Addendum # 1**1 Changes:**

2.1 - Re-Issued Drawings

12522-01 NANOOSE BAY PENINSULA PUMP STATION

TITLE	Free Chlorine □ pH Analyzer Pac □ Age	DRAWING NO.	B1599	REV.	A
REPLACED BY	-	SHEET	1 OF 1

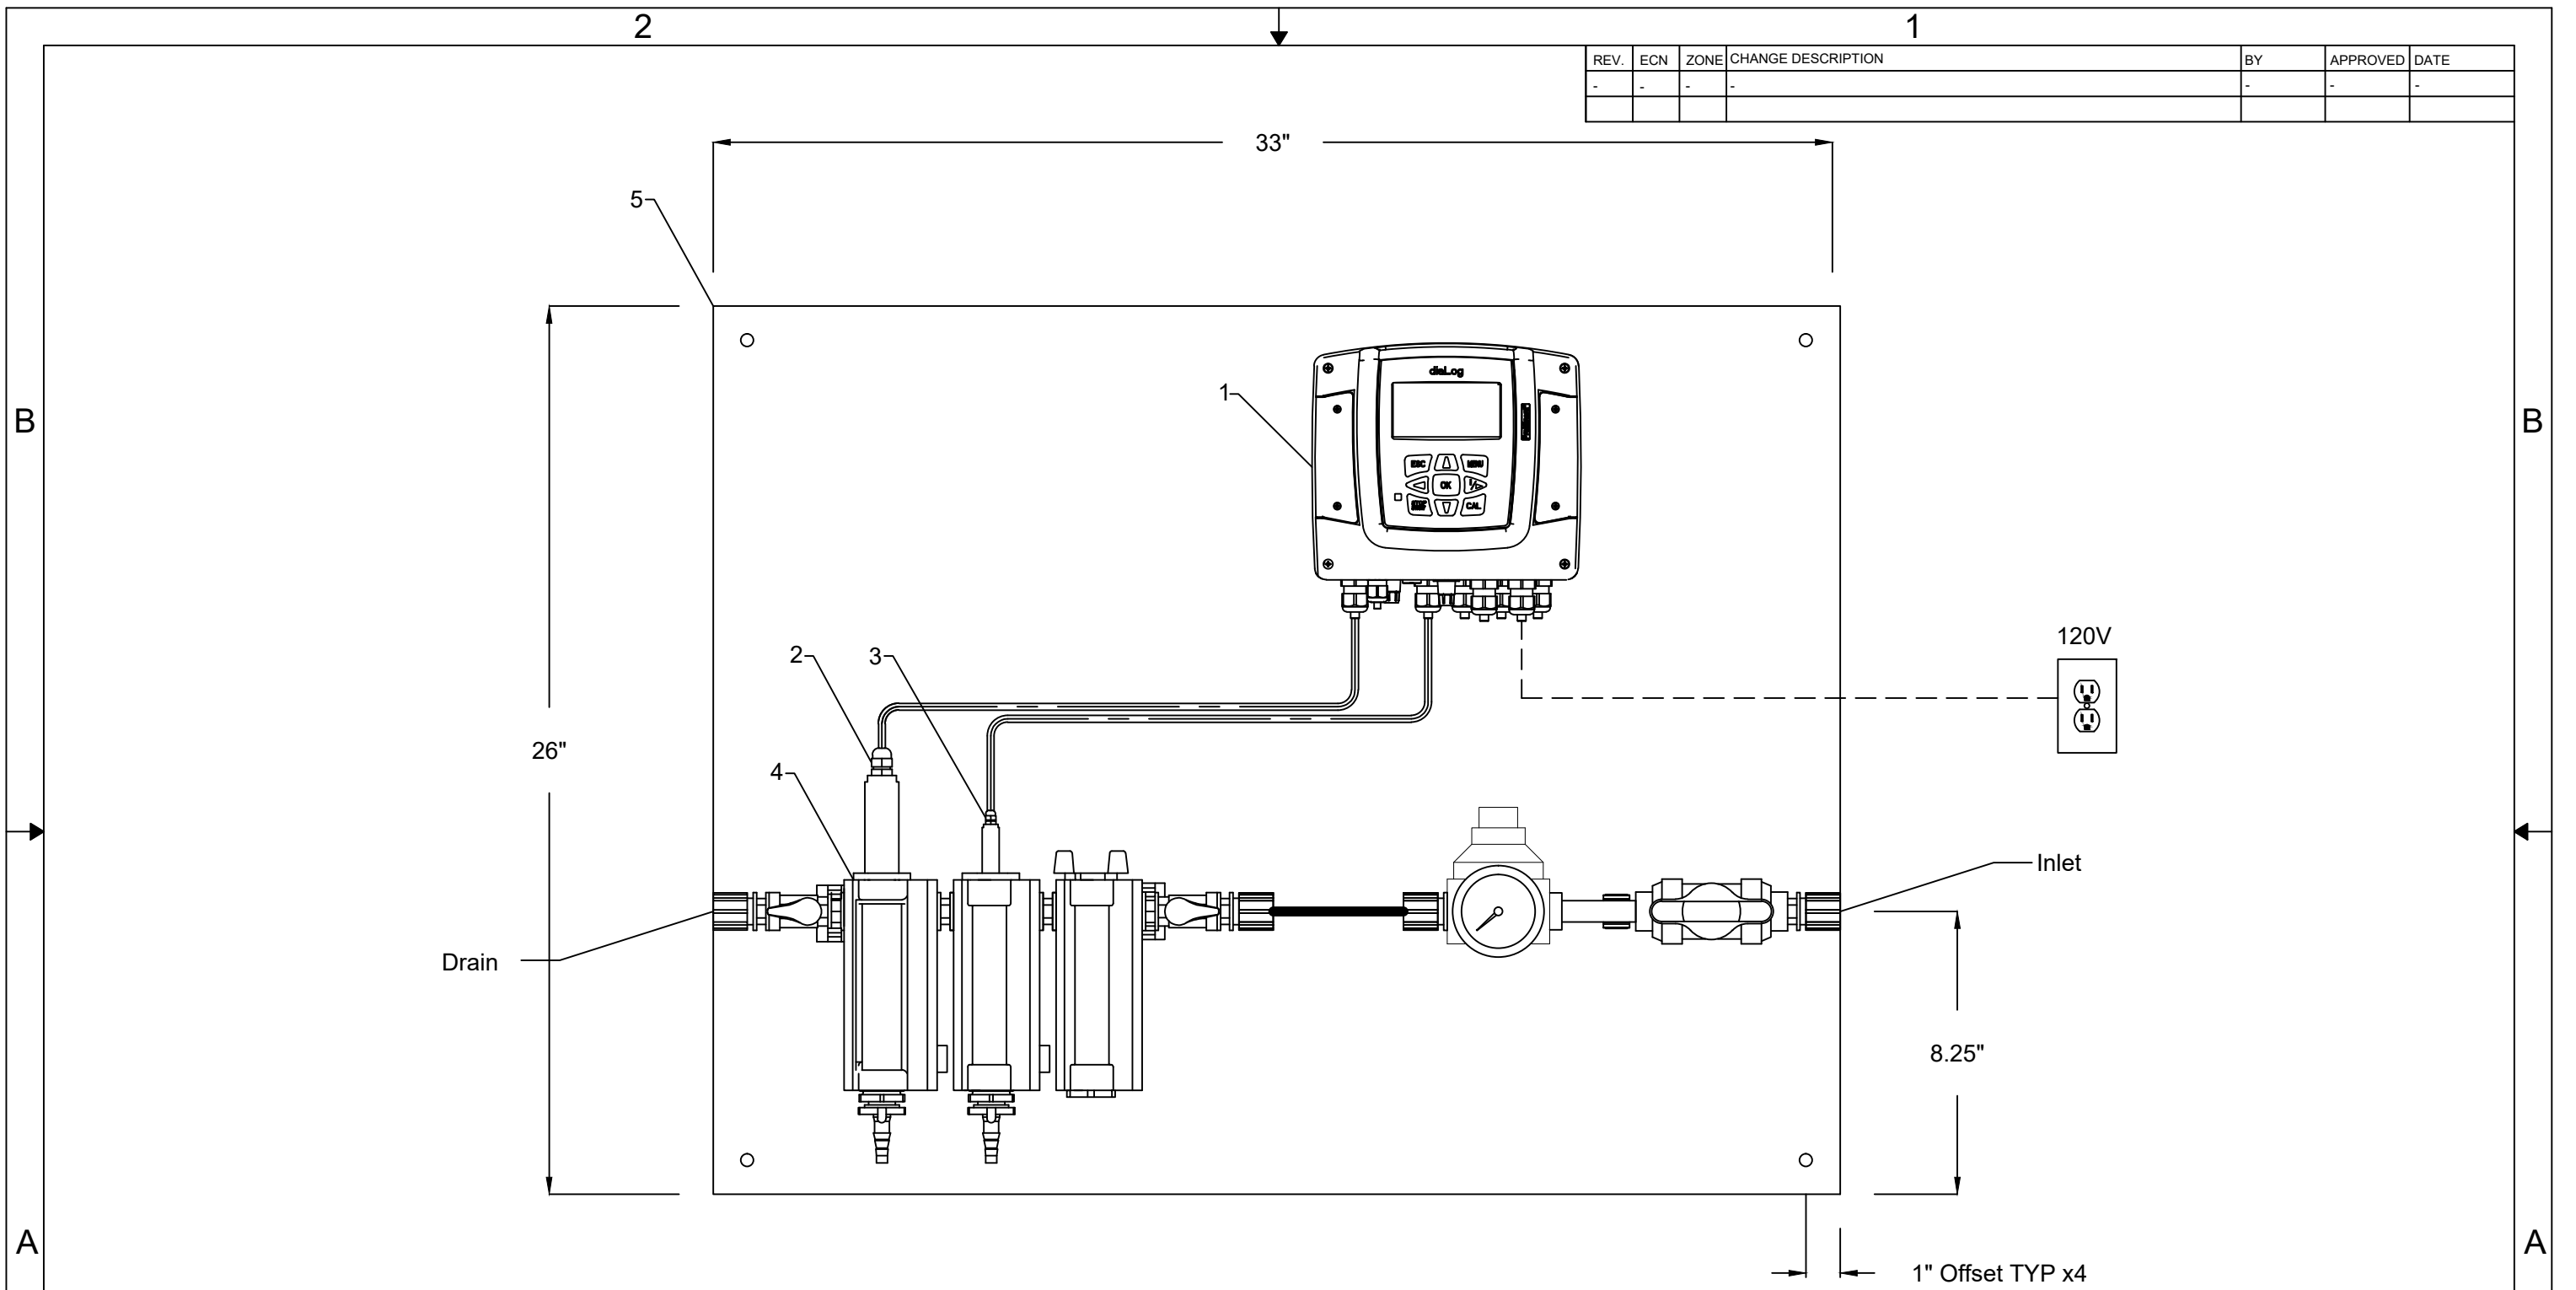
- Remove 11.2 Control Philosophy & Operational Strategy contained in the original Tender Documents and replace with the attached document.
- Remove 11.3 Smith Cameron Quotation and replace with the attached document.
- Add 11.4 Chlorine Information from Smith Cameron
- Add 11.5 RDN Approved Products List
